CHECKING
FUEL-INJECTION PUMPS

Workshop: EP
08.1997
ST 0568 De

Modification of idle leaf spring

1. On FIP without any damage, using standard Bosch repair procedures, replace the current bearing end plate with the new version PN F 002 A11 208 (Pos. 1).

KMK09525

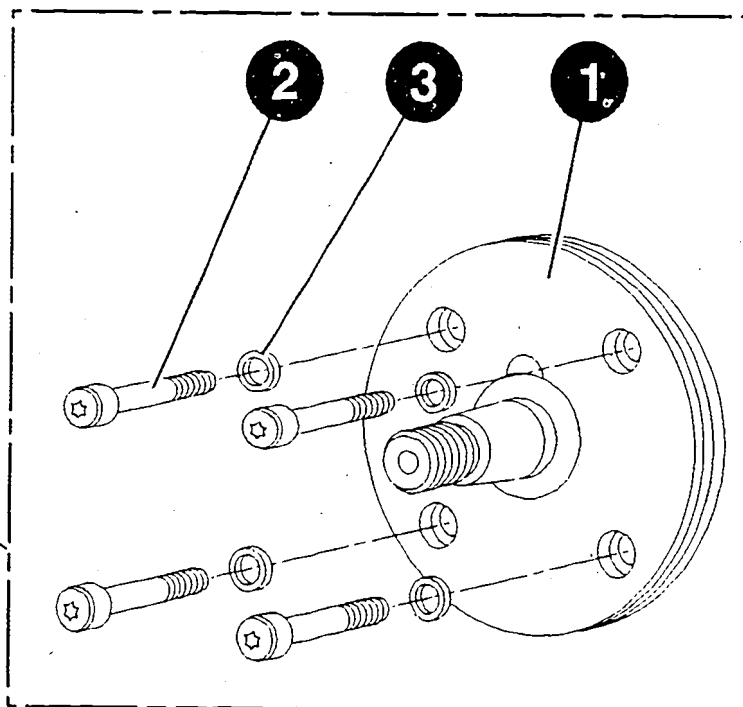
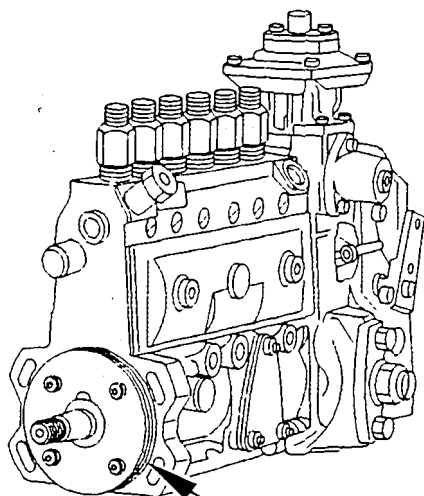
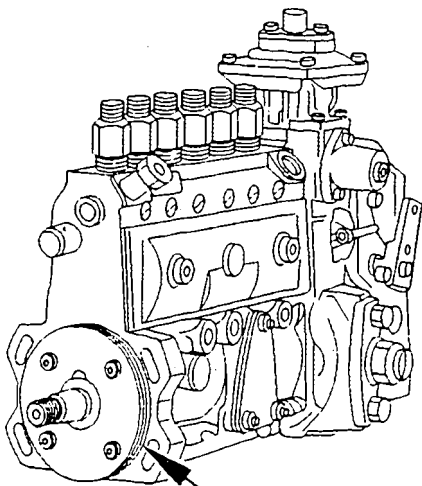
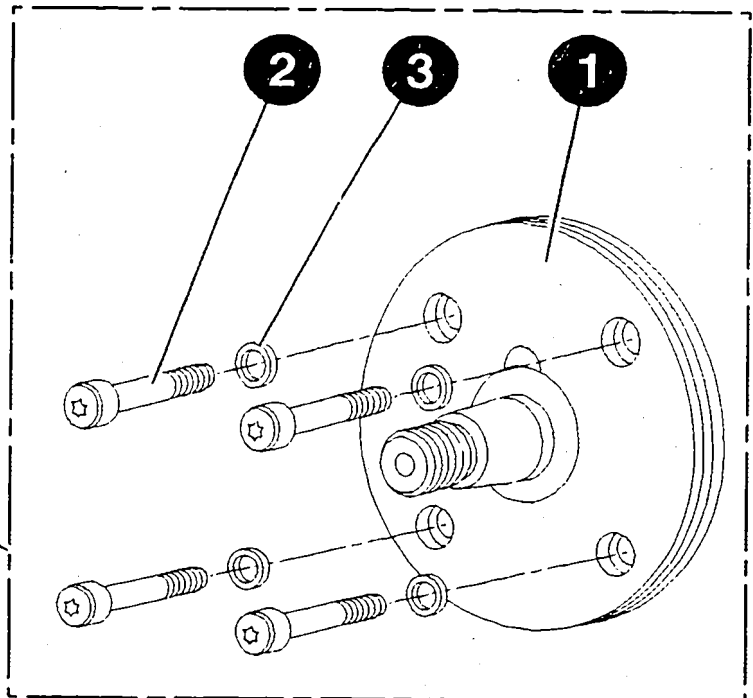
Discard the old screws and replace with new low head Torx screws M6 x 18 mm grade 10.9, PN 2 912 742 199 (Pos. 2).

Clean the screw bores in the FIP housing, install the screws and steel spacers PN 1 410 100 037 (Pos. 3) with Loctite 270 following manufacturers recommendations and torque to 10 +1 Nm, loosen and retorque again to 10 +1 Nm. Refer to the parts list for all other parts and gaskets necessary.

KMK09771

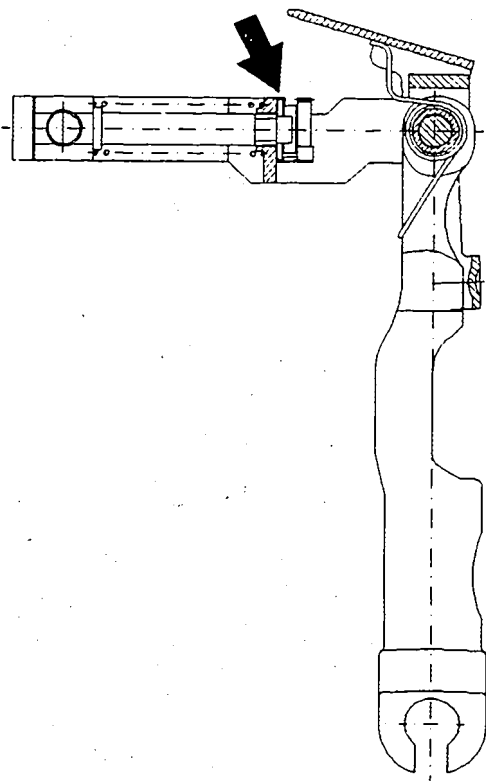
This is due to a sticking lock washer in the link fork of the governor (Fig., arrow).

Disengage accelerator and shutoff linkage or Bowden cable. Screw out large screw plug in governor cover (item 1). Fully deflect control lever and actuate shutoff lever at the same time. A visual inspection through the open hole in the governor cover makes it possible to determine whether or not the lock washer in the link fork of the governor is sticking. If it is, detach entire pump assembly from engine and, following removal, replace fulcrum-lever unit (item 2) with a new one.

KMK09772

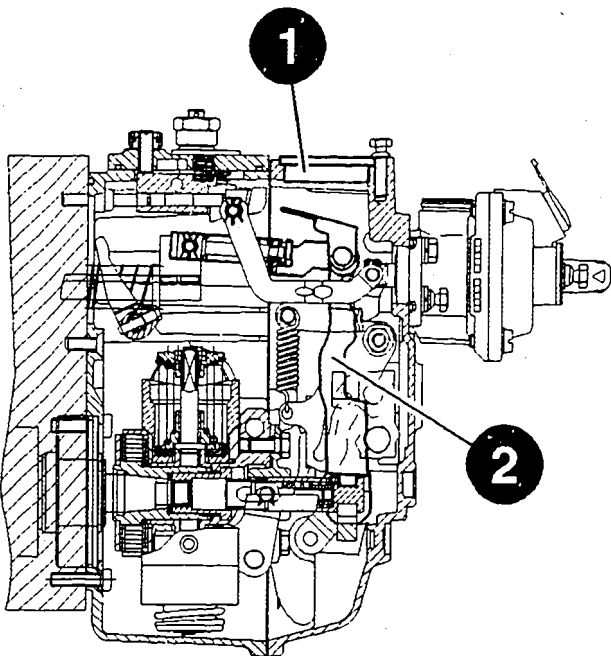
Check freedom of movement of lock washer before installing new fulcrum-lever unit.

KMK09801

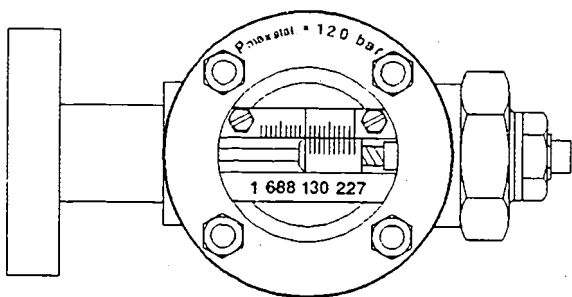
FOR SAFETY REASONS (DESTRUCTION OF VIEWING PORT), PREVIOUS MEASURING TOOL (1 688 130 139) IS NOT TO BE USED FOR TESTING L2 VE PUMPS.

FOR CHECKING HEAVY-DUTY VE PUMPS (L2), EXCLUSIVE USE IS TO BE MADE OF THE NEW TIMING-DEVICE TRAVEL MEASURING TOOL, PART NO. 1 688 130 227.

FAULT RECTIFICATION, SOLDERING SPECIFICATION

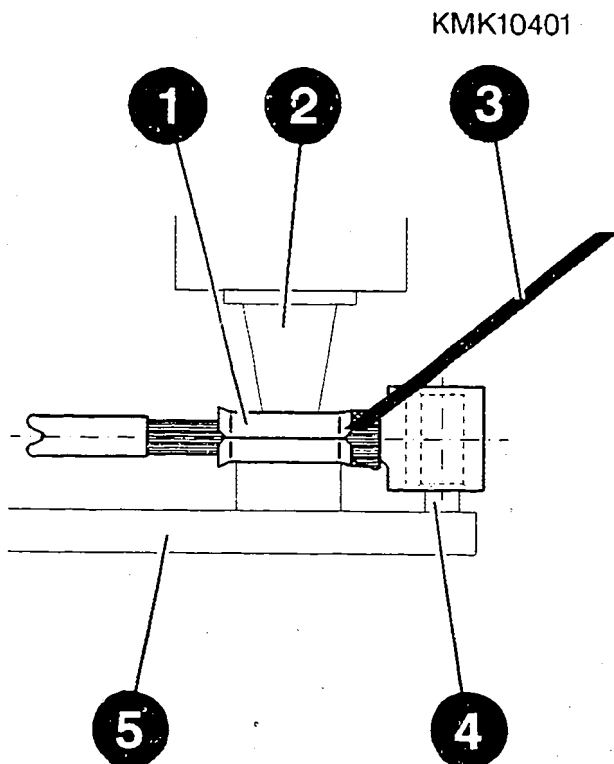
After dismantling the positioner cover, the crimp connections of the rack position sensor leads are to be additionally soldered on the sensor and connector ends.

As regards soldering equipment and instructions, reference is made to the detailed information given in the test and repair instructions for M/RE 22 positioners. Particular attention is to be paid to the correct soldering-iron tip temperature (350...370 C). Otherwise, use is to be made of a solder wire with integrated flux, diameter approx. 1 mm.

KMK11881

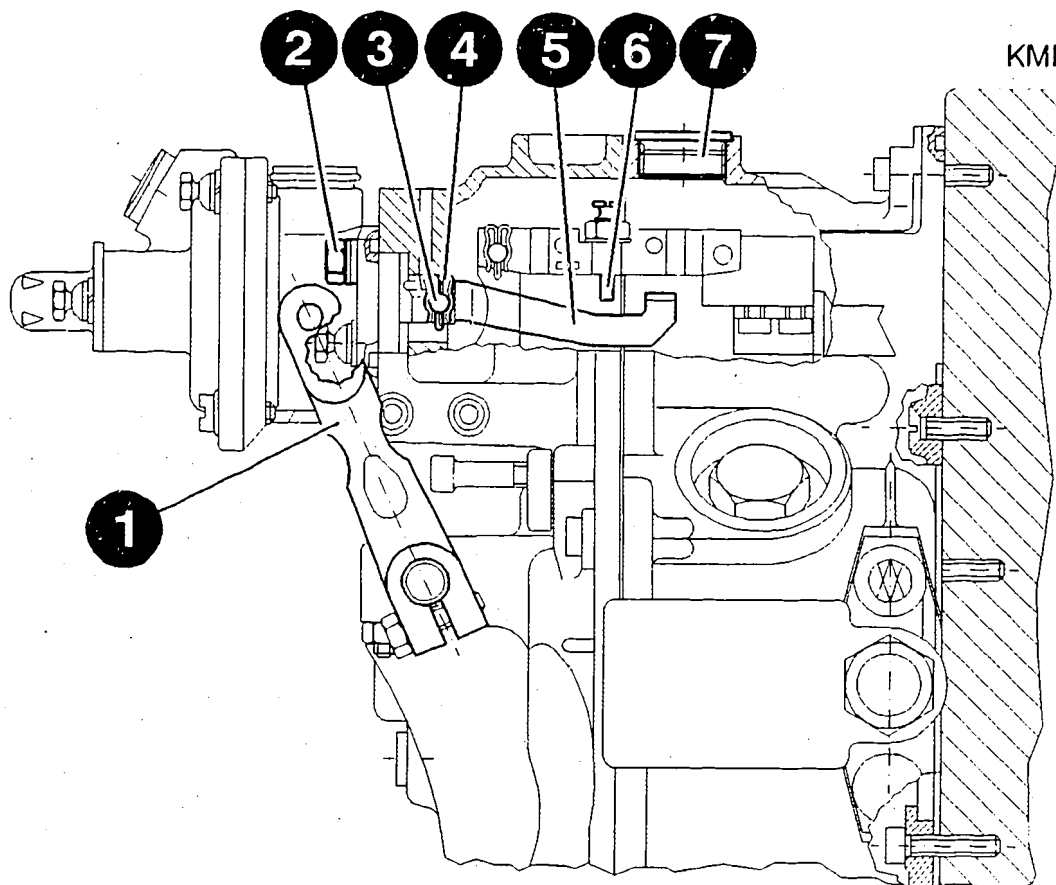
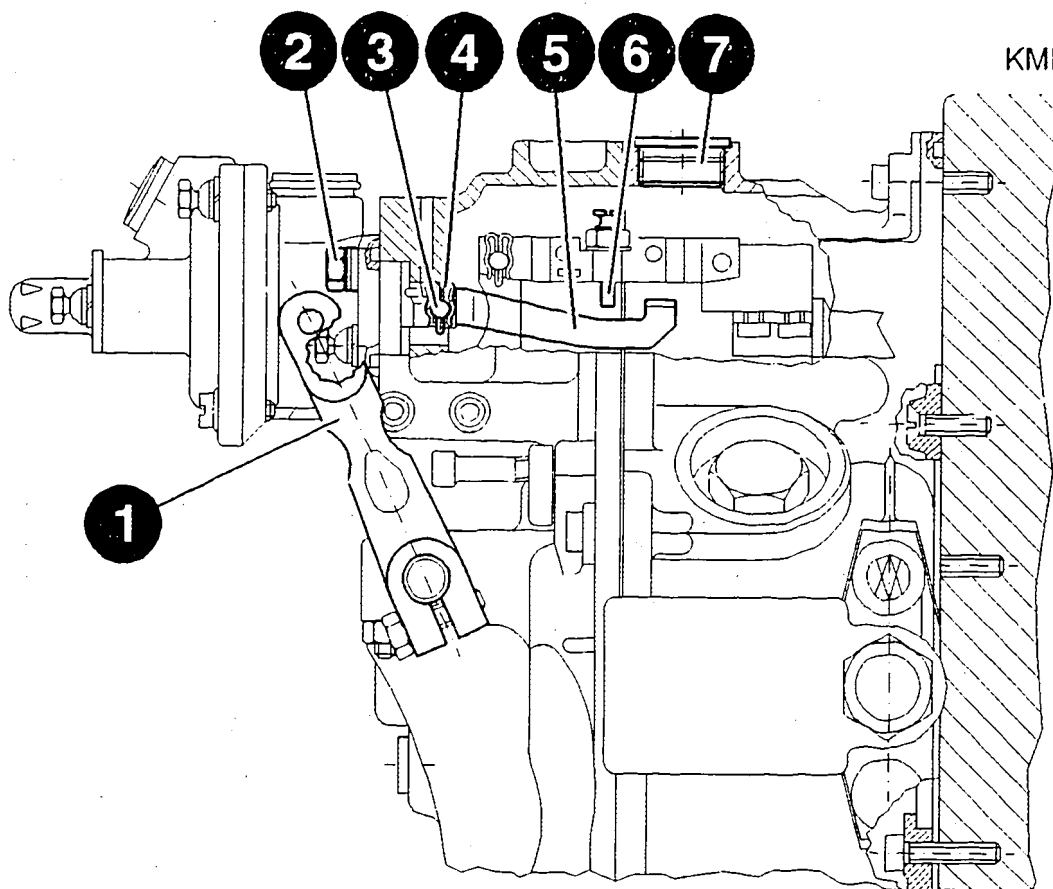
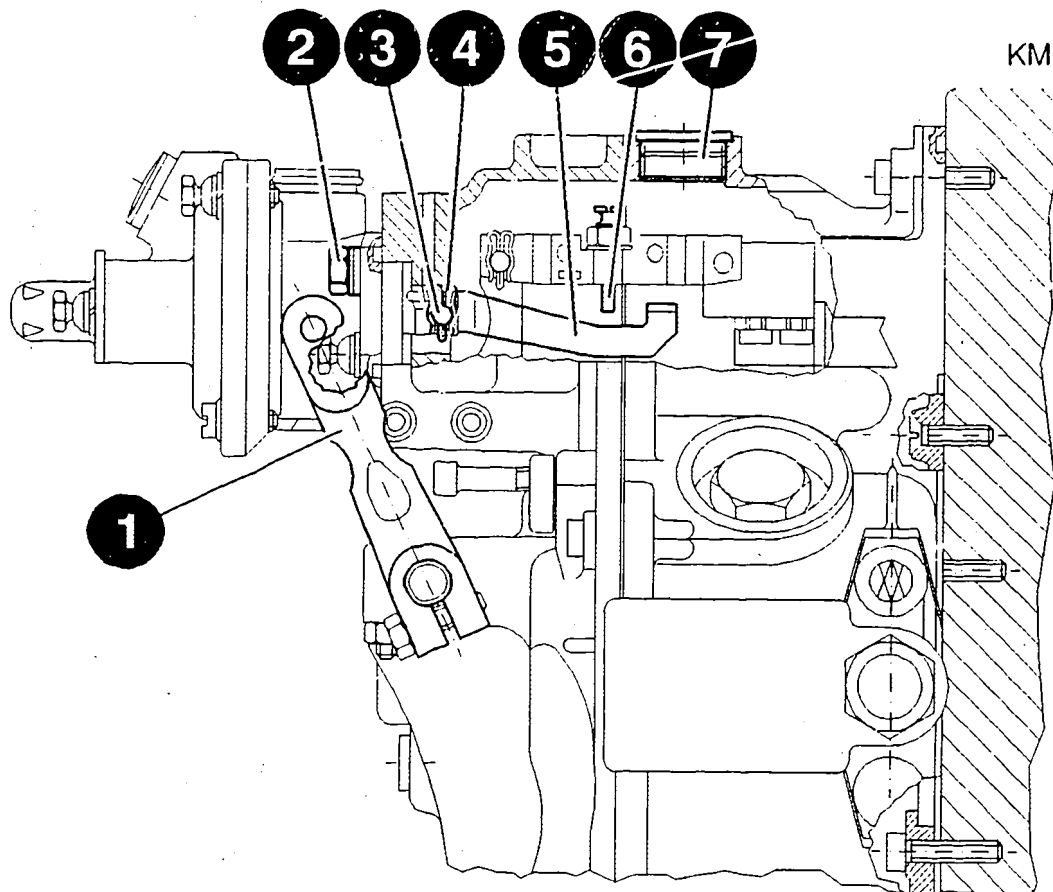
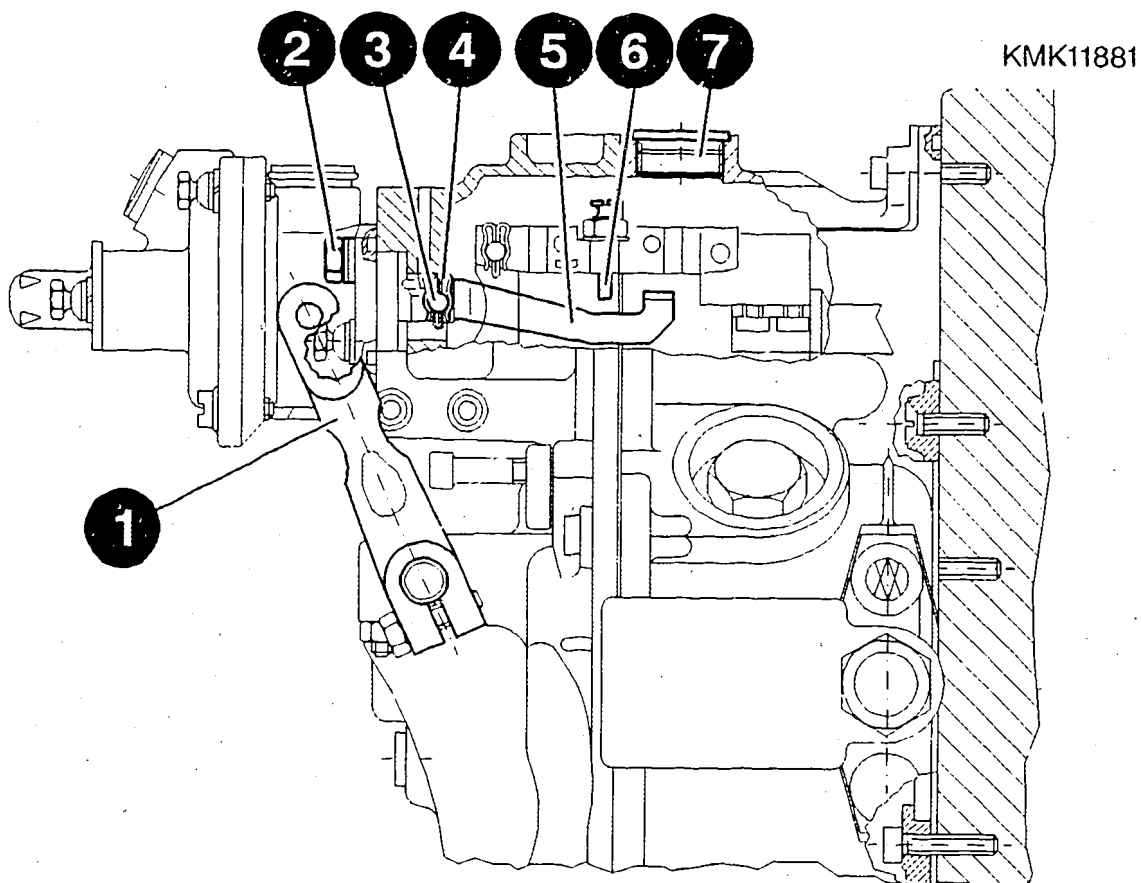
- * Control-rack travel measurement
Attach control-rack travel measuring instrument to pump removed.
Establish and note down control-rack travel measured value V_S (full-load intake).
Apply 1.5 bar to LDA (e.g. using Duovac pump) and note down V_I (full-load control-rack travel).

- * Detachment of LDA
 - Screw out bolts (2) (loosen shear bolt with hammer and chisel).
Screw back idle screw at control lever (1) as far as it will go.
 - Pull control lever into "shutoff" position.
 - Pull out LDA roughly 10 mm, then turn counter-clockwise through 90 (as viewed from governor end) and take out carefully.

- * Replacement of plate
 - Pull off locking spring (4).
 - Remove LDA plate (5) from lifting rod.
 - Attach new LDA plate (5).
 - Fit new locking spring (4).

- * Attachment of LDA
 - Move control lever (1) to shutoff position.
 - Turn LDA with LDA plate (5) counter-clockwise through 90 (as viewed from governor end) and insert carefully into top opening in governor cover.
 - Bypass stop pin (6), turn LDA (clockwise) to normal position and guide in last 10 mm.
 - Tighten LDA bolt (2) slightly.

LDA plate (5) is swivel mounted in LDA housing. Incorrect procedure can cause it to become twisted and lead to setting problems/excessive quantity scatter.

KMK11902

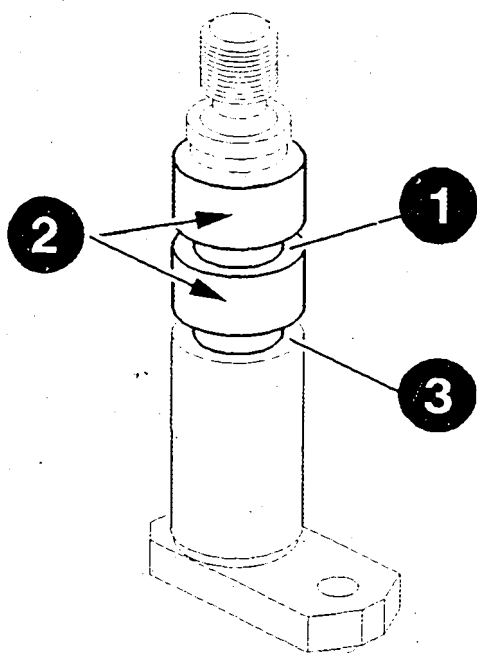
The problem arises from a lack of
grease in the O-ring groove and the
area between the O-rings.

- 1 = Upper O-ring groove
- 2 = Area between O-rings
- 3 = Lower O-ring groove

KMK11903

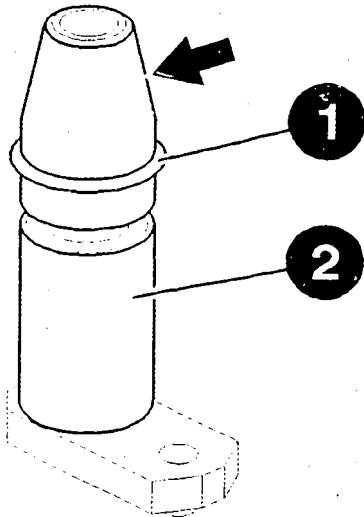
Fill lower O-ring groove with Molycote.
To protect O-ring, mount assembly sleeve 0 986 611 291 KDEP 2937 (arrow) on control lever shaft.

Slip on lower O-ring until it engages
in groove (in grease).
Remove adhesive tape.
Fill upper O-ring groove with Molycote.
Fit O-ring (O-ring must engage in
grease).
Grease control lever shaft all round
with Molycote between O-rings.
Install control lever shaft in
bushing.
